In Reply Refer To: GE 1035A

April 18, 2012

Application Type: Right-of-Way Modification
Application Date: November 10, 2009
Supplemental Data Dates: December 23, 2009 and March 26, 2010

Assigned Pipeline Segment Number: 16128
Assigned Casing Segment Number: 17459
Assigned Umbilical Segment Number: 17722
Assigned Right-of-Way Number: OCS-G28452

Figure 1: BSDV Pressure vs Time (Flowing and Shut-In)

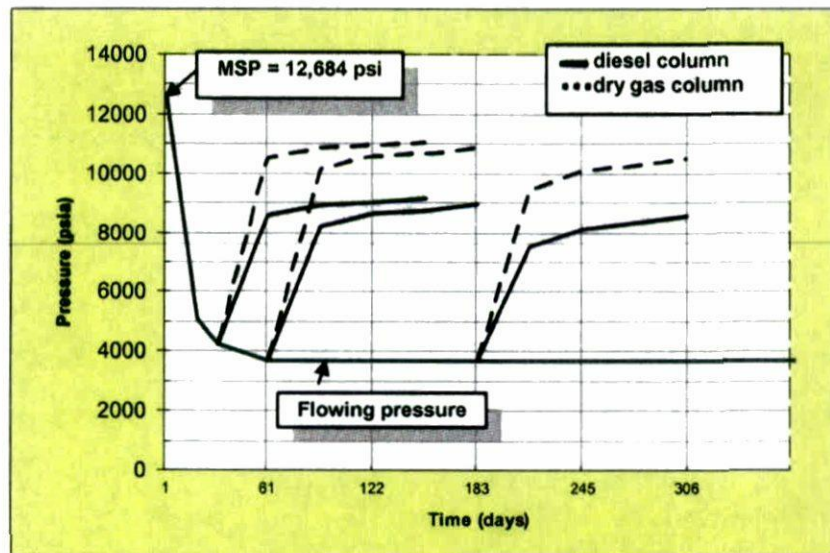
PAI has been requested to address in more detail the issue of shut-in time versus pressure build-up as it relates to MAOP. PAI utilized the flow assurance study results, combined with reservoir depletion model results to investigate the development of the BSDV shut-in pressure over time. A dry gas column case and a diesel column case (as described above) were studied for Cascade and Chinook. The results are described in the following paragraphs.

In Figure 1 below the "flowing pressure" curve (in green) represents the maximum source pressure as wells are opened to flow. Superimposed on that flowing pressure curve are curves for three BSDV shut-in scenarios. These are: shut-in after 30 days of production, after 60 days of production and after 180 days of production. A case representing a dry gas column (dotted lines) and a diesel column case (solid lines) were investigated for each of these shut-in scenarios. As expected, all diesel column curves easily fall below the MAOP of

10,000 psi proposed by PAI shortly after initiating production. For the theoretical case of a full column of dry gas, after one month of production, it takes about 30 days for the boarding valve shut-in pressure to reach 10,000 psi. After six months of production it takes 60 days.

These curves show that even in the theoretical case of dry gas the BSDV shut-in pressure will be below 10,000 psi for at least 30 days after shut-in. In addition this will require both of the following triggers to occur:

Figure 1: BSDV Pressure vs Time (Flowing and Shut-In)

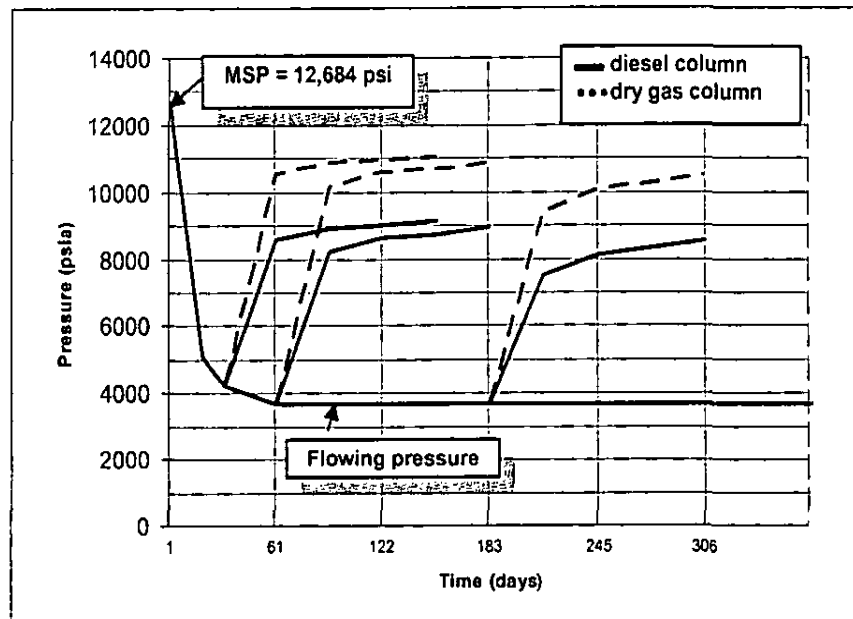
Item number one indicated your request for PAI to provide the settle out pressure and start times (days) for each of the six curves on Figure 1, Page 4 of 6. In response PAI respectfully offers the following:

The Boarding Shut-Down Valve (BSDV) shut-in pressure values were calculated using Well Bottom Hole Pressure (WBHP) values obtained in the reservoir flow simulations.

The WHTSIP values above were translated to the BSDV elevation by subtracting the weight of the diesel or gas column (3,342 psi or 1,403 psi, respectively). The following example illustrates this process:

From Table 1, the WHTSIP 30 days after closing the well is 11,936.43 psi. The corresponding BSDV for the theoretical case of dry gas is 11,936 minus 1,403 =

10,533 psi. This value is noted in Table 4 below. A similar procedure was used to determine the other BSDV shut-in pressure values.

The resulting BSDV shut-in pressure values are given in Tables 4 and 5. These pressures were used to construct the curves shown in previous communication, and included again as Figure 1, following the tables below.
